TOWN OF PALM BEACH

PZ&B Staff Combination Memorandum: Town Council and Architectural Commission

SUBJECT: ARC-24-012 212 WORTH AVENUE

MEETING: JANUARY 24, 2024 ARCOM

Existing / Proposed

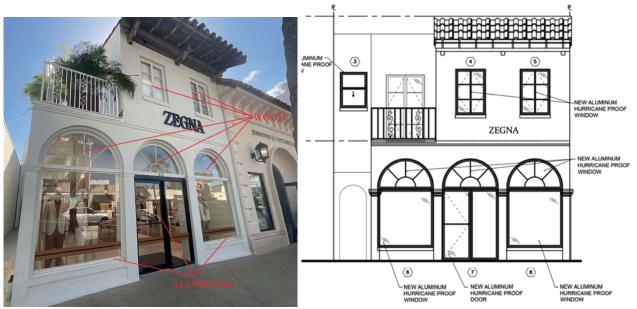
The most significant portion of the application is the replacement of the fanlight transom windows that are currently wood with an aluminum product of the same design. Additionally, the second-floor features two paired casement windows that are visible from the street. These three lite per panel windows are wood and would also be modified to aluminum. Other single hung or fixed windows (ten total) are not readily visible on the north and south elevation of the building. Lite patterns and general design are not changing however the profile of the muntins and frames would be slightly different than existing since an aluminum impact product is proposed and the inherent nature of that changes the width and profile.
